# City of Santa Fe, New Mexico

# memo

**2025-010873-HDRB, 219 and 219 A Washington Ave, Downtown & Eastside Historic District,** Contributing, Robert Evans, agent for Dennis Price, owner, requests approval for a 661 sq. ft. addition including a two-story structure to a height of 19'-8" at 219 Washington Ave and construct a new 973 sq. ft. two-story structure at 219 A Washington Ave to a height of 23'-0" where the max allowable is 20'-1". Exceptions are requested to 14-5.2(D)(2)(d) an addition shall not exceed fifty percent of the square footage of the existing footprint and 14-5.2(D)(9) height.

Figure 5. Proposed 219 Washington Ave West Elevation.

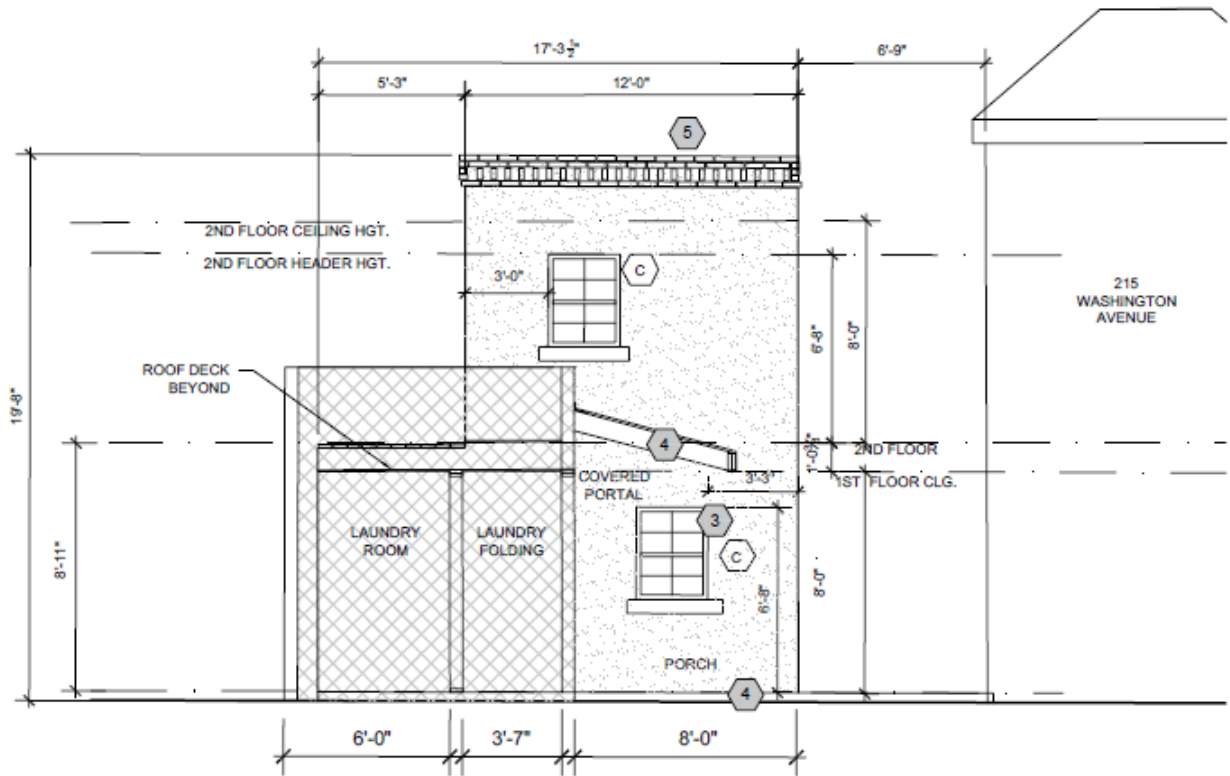
*The addition of a Territorial Revival parapet with a brick coping to the existing historic garage structure creates a false sense of history for this historically contributing building. So as to not threaten the contributing status of the building, no brick coping should be added to the existing historic structure. The proposed additions may have a brick coping.*

Staff has concern with the addition of a brick coping to the historic garage structure, which is designated as contributing. The addition of the coping creates a false sense of history. To preserve the status of the historic building, no brick coping should be added to the original footprint of the structure.

Figure 6. Proposed 219 Washington Ave Second Story Addition West Elevation.

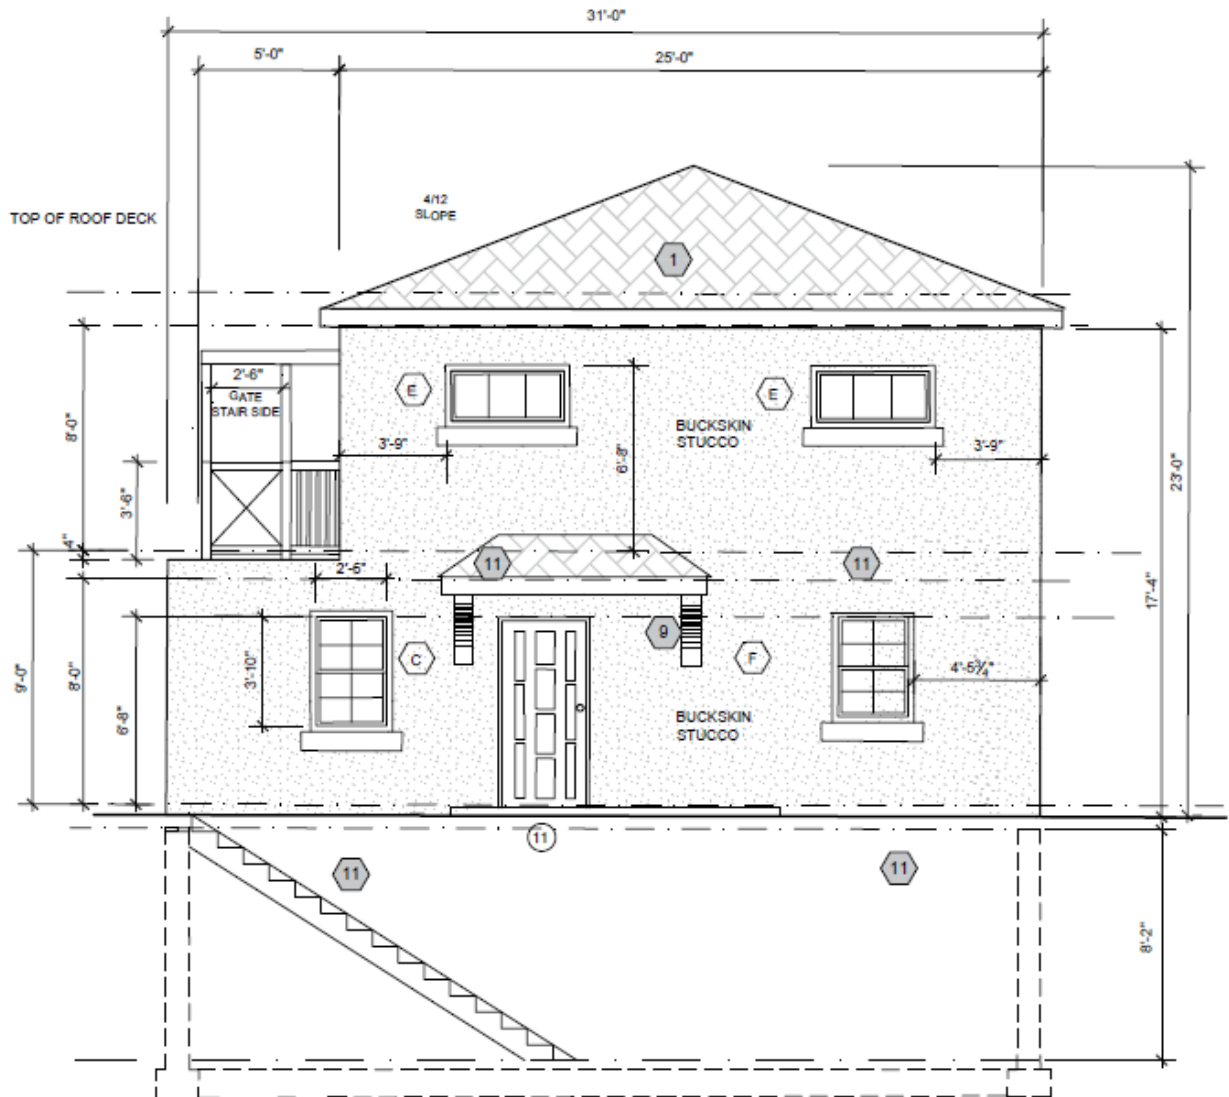
Exception to 14-5.2(D)(2)(d) an addition shall not exceed fifty percent of the square footage of the existing footprint: Staff requests an exception to 14-5.2(D)(2)(d) as the proposed 628 sq. ft. addition exceeds fifty percent of the existing 897 sq. Ft footprint.

Staff Response: Staff has evaluated the applicant’s response and finds that the criterion has been met. The original structure at 219 Washington Ave served as a garage. It was renovated

and became office space. The proposed development of the property will not impact the contributing status or the west primary street facing façade. The additional square footage is necessary for the remodeling of the structure from professional office space to hotel space.
